TECHNICAL NOTE			VELOCITY
Client	Building Construction Partnership		Page No. 1 of 5
Project	Dene Holm, Northfleet, Gravesend, Kent		Project No. 25/220
Subject	Response to Highways Comments		Document No TN01
Prepared By	AM	Checked and Authorised By ML	Date SEP 2026

- 1.1.1 This technical note has been produced to respond to Highways comments (dated 30th July 2026) received from Kent County Council (KCC) in relation to the redevelopment proposals for Dene Holm House (application reference GB/20260153), located in Northfleet.
- 1.1.2 The proposals are for the demolition of the existing care home and the erection of a replacement 60-bedroom care facility together with six rehabilitation apartments.
- 1.1.3 This note sets out each of the comments received from Highways and is then followed by Velocity's response in green.

UPDATED SITE LAYOUT PLAN

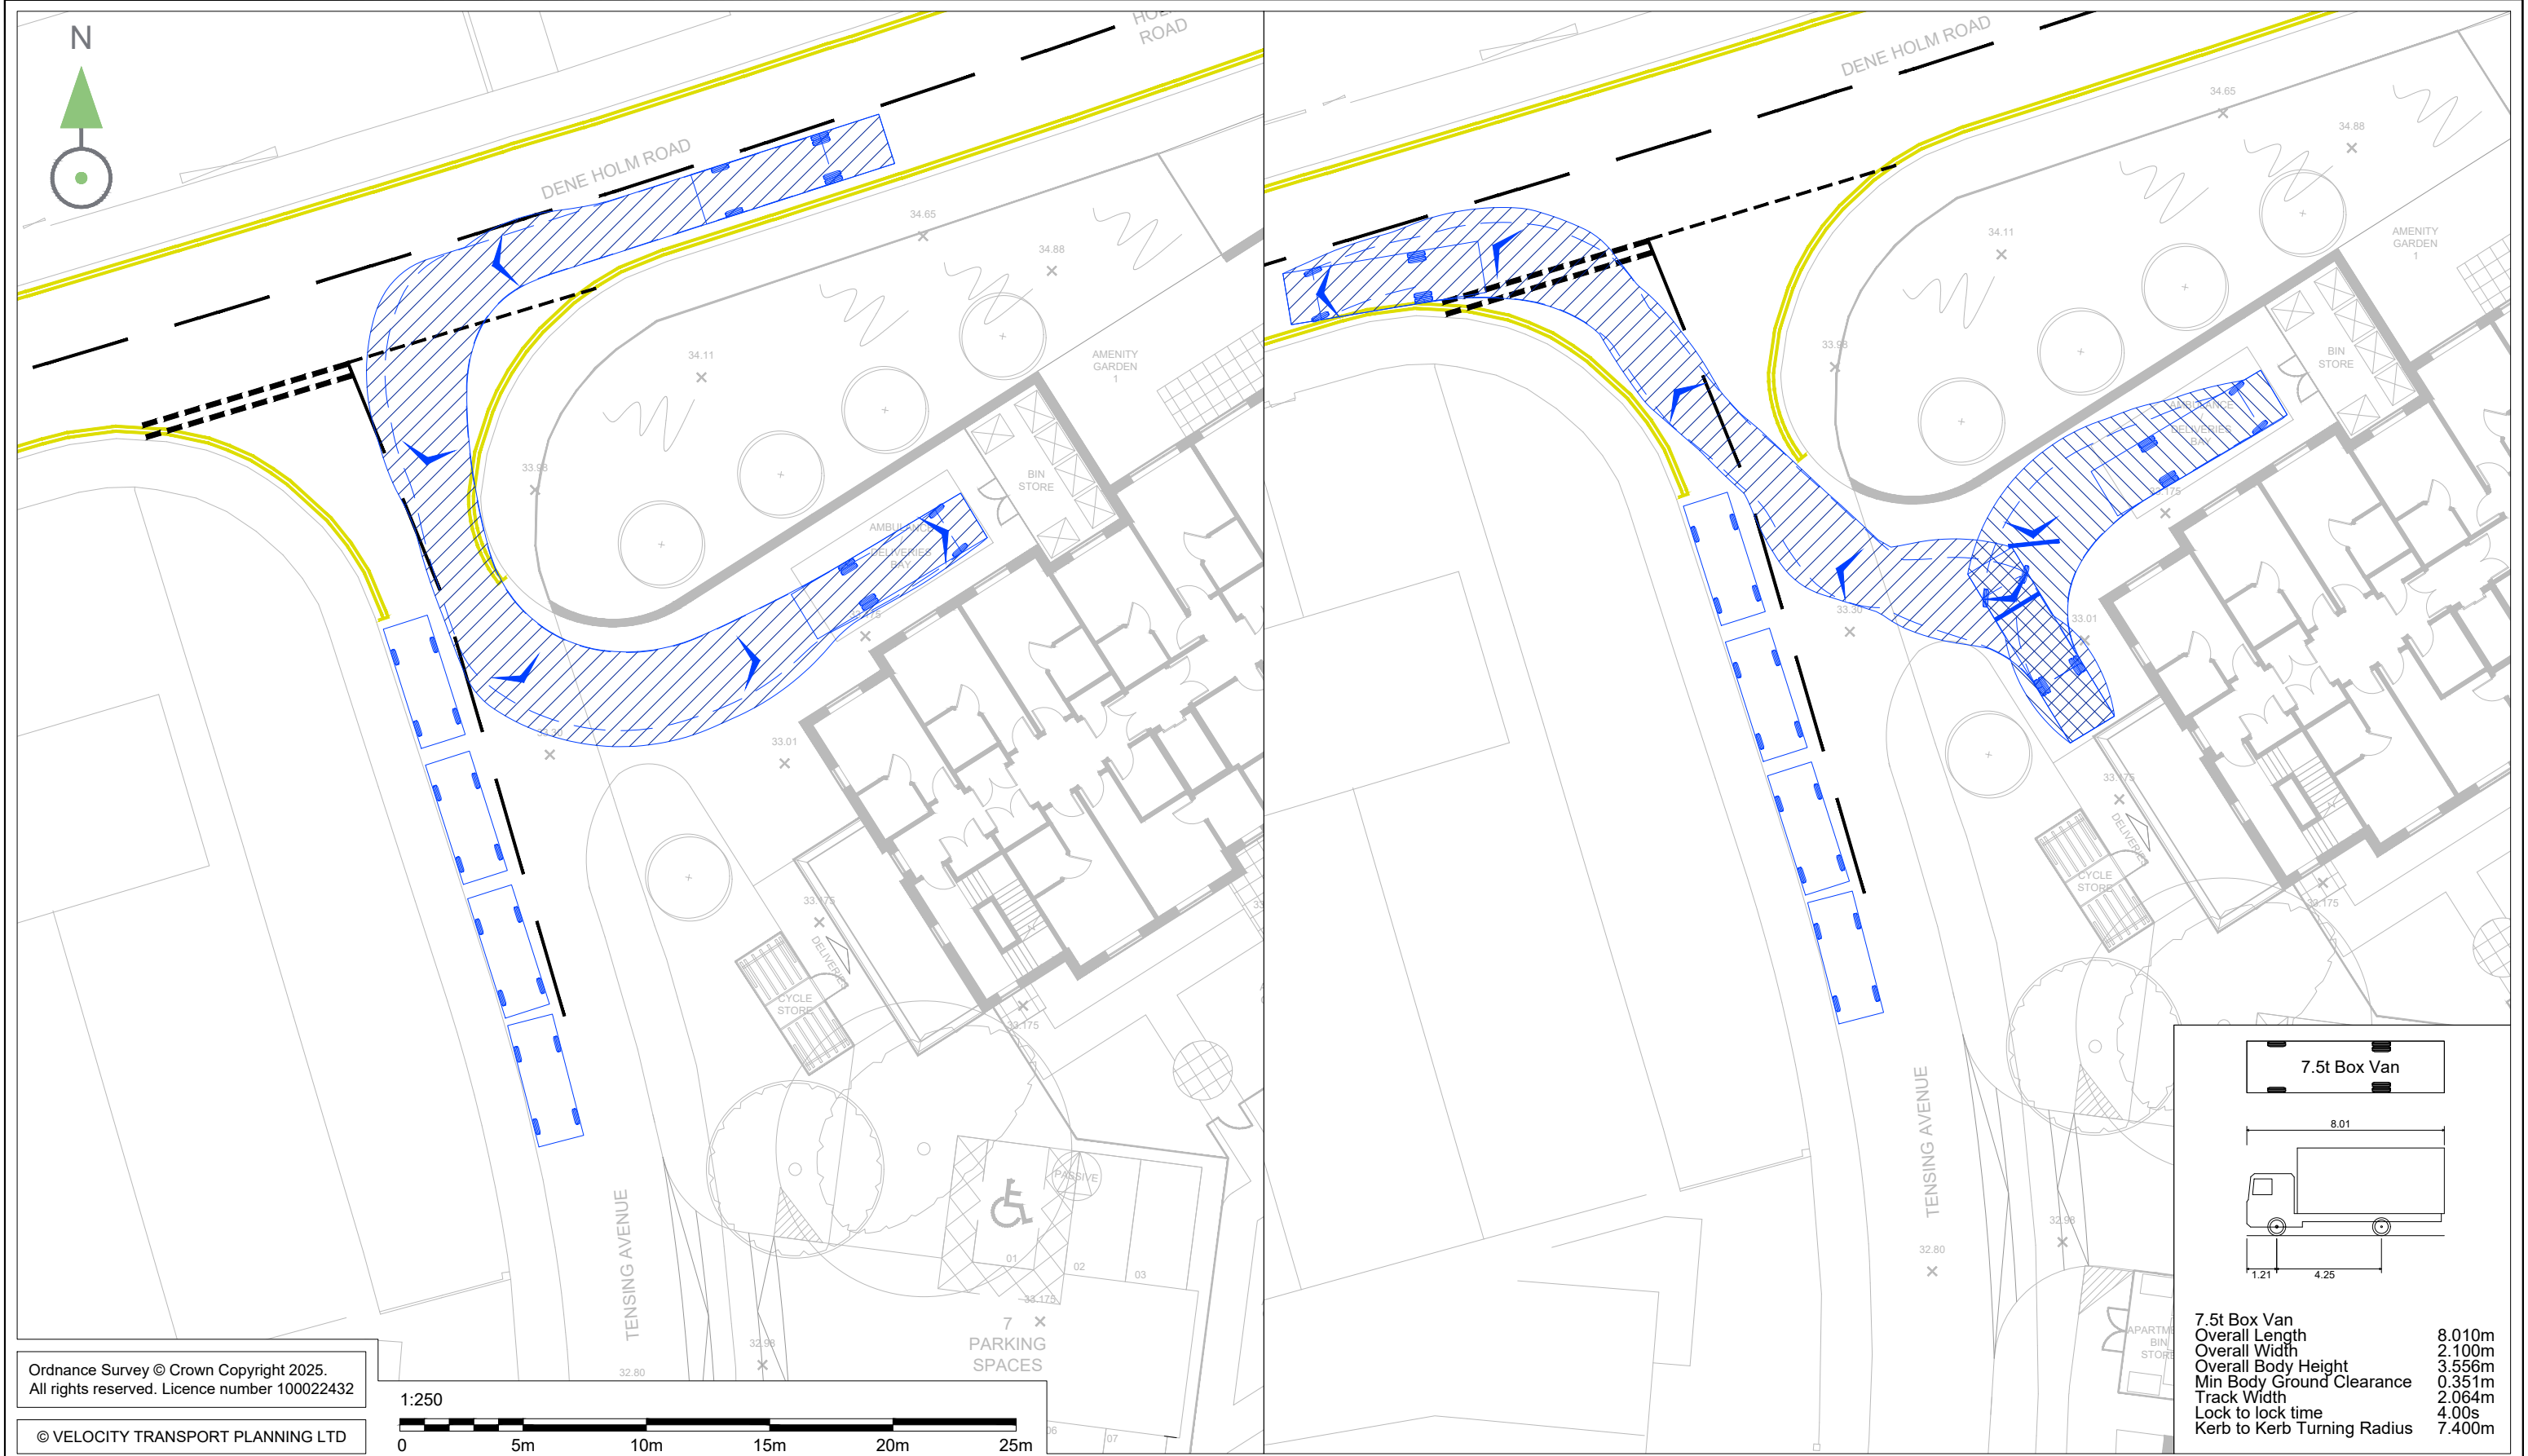
1.2.9 Concerns are raised regarding the suitability of this arrangement. Insufficient information has been provided to demonstrate that ambulance access, refuse collection activities and cycle parking can operate safely and efficiently without conflict between users.

1.6.3 The inclusion of two accessible parking spaces is welcomed; however, the applicant may wish to review the level and location of accessible parking provision, particularly in relation to the rehabilitation apartments, given the nature of the proposed use.

1.6.5 Electric Vehicle charging infrastructure should be provided in accordance with current Building Regulations requirements.

1.2.10 **The comment is noted, given the low frequency of ambulance visits and refuse collection, the potential for conflict between these different users is expected to very low. Regardless of this, the cycle parking has been moved away from the bin store and ambulance bay, and is now located off of the servicing area, towards the delivery entrance (as shown in the revised layout plan provided at APPENDIX B).**

1.2.11 **This arrangement will allow cyclists to enter the site and be clear of these other activities before dismounting their bicycle and then storing their bike.**

1.6.4 The comment relating to the parking provision is noted, an additional accessible bay has been provided within the car park for the rehabilitation apartments, this is demonstrated on the updated layout plan provided at APPENDIX B.

1.6.6 Noted, the updated site layout (provided at APPENDIX B) shows that electric vehicle charging provision has now been included, as per the current building regulations. In terms of active provision, a charging point will be provided outside the main entrance and will provide power to one accessible bay and one standard parking bay.

1.6.7 For passive provision the infrastructure for a further two bays will be provided at the southern end of the main car park. A further two bays will be provided with passive provision within the rehabilitation apartments car park.

DRAWING 25-220-SK-010-A

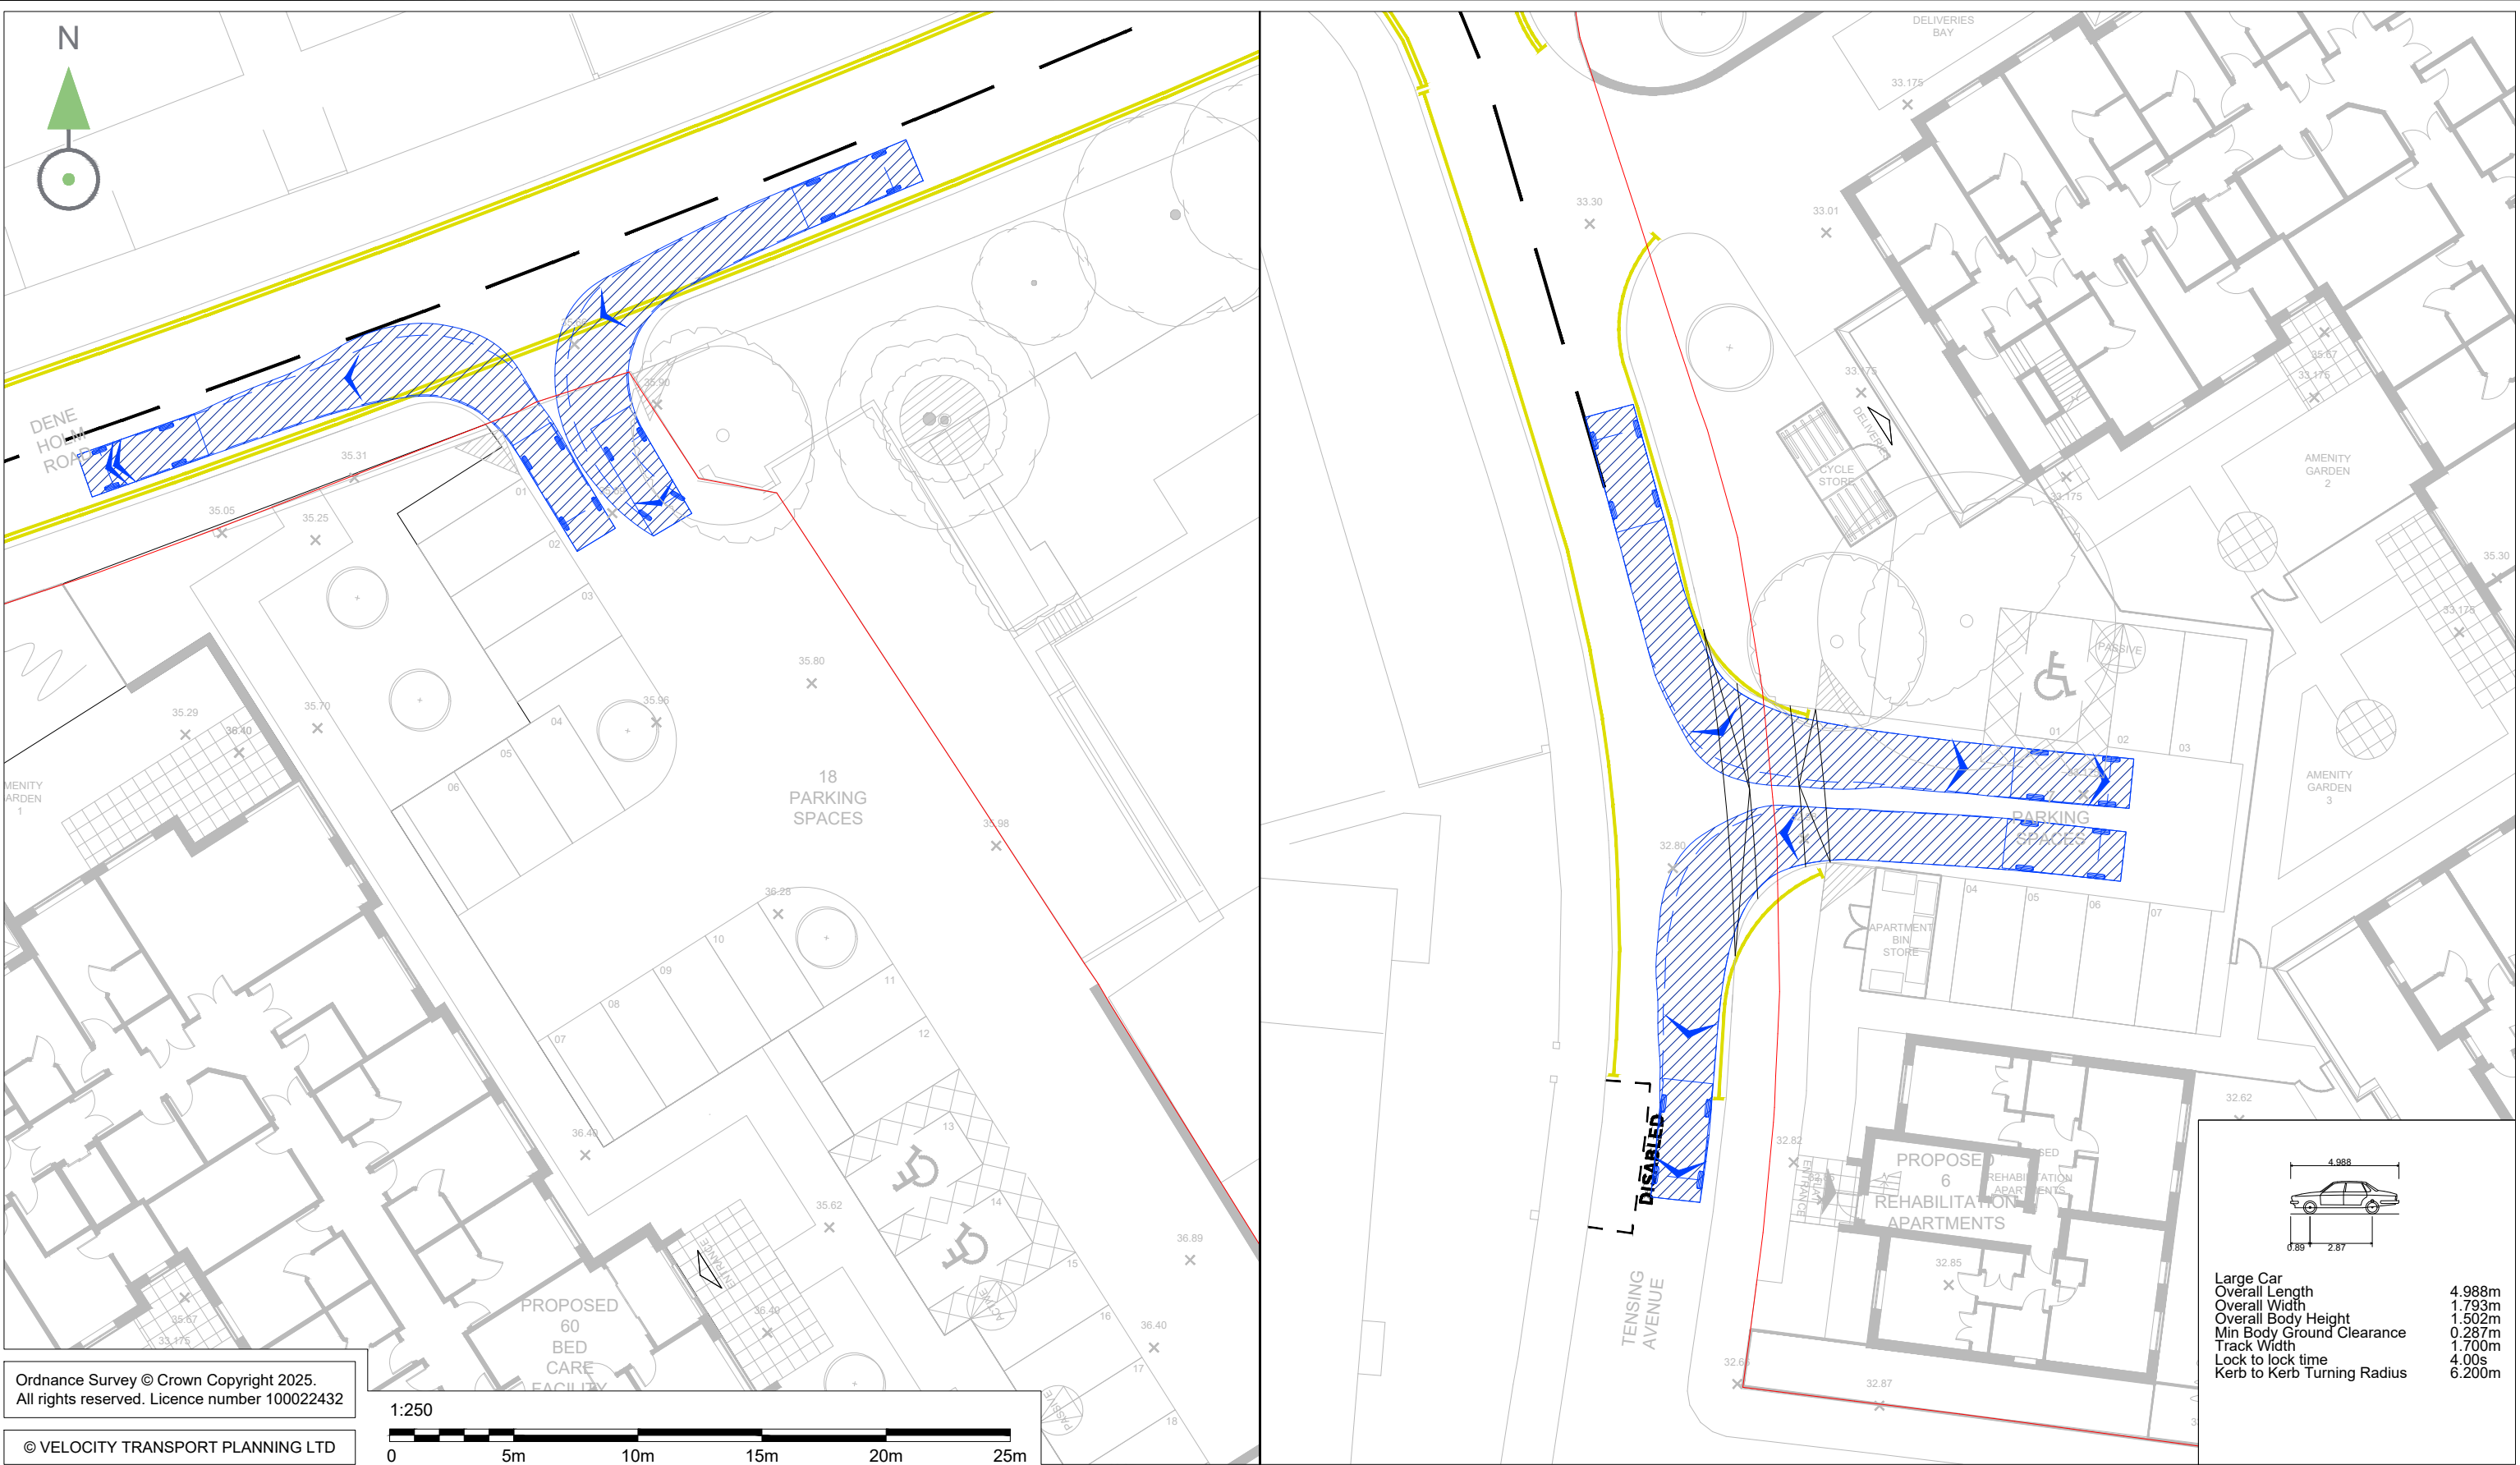
1.2.17 Swept path analysis should be provided for an 11.4m refuse vehicle demonstrating safe access to, manoeuvring within and egress from the site. The analysis should demonstrate that refuse collection can be undertaken without reliance on the proposed TRO.

- 1.2.18 The plan provided at APPENDIX E (Drawing 25-220-SK-010) shows that a 11.4m refuse vehicle is able to pull up outside the servicing access and have the refuse bins wheeled to the rear of the vehicle for collection (9m drag distance from the collection point). The site management team will be responsible for bringing the bins out of their store and putting them away again after each refuse collection.
- 1.2.19 In addition, the cycle parking and refuse storage should be separated from the ambulance bay to ensure that access to these facilities is not impeded when the ambulance space is occupied.
- 1.2.20 As previously discussed, the cycle parking store has been relocated in order to ensure the safe operation of the delivery and servicing area. Given the infrequent nature of both ambulance call outs and refuse collection it is very unlikely that these activities will overlap.
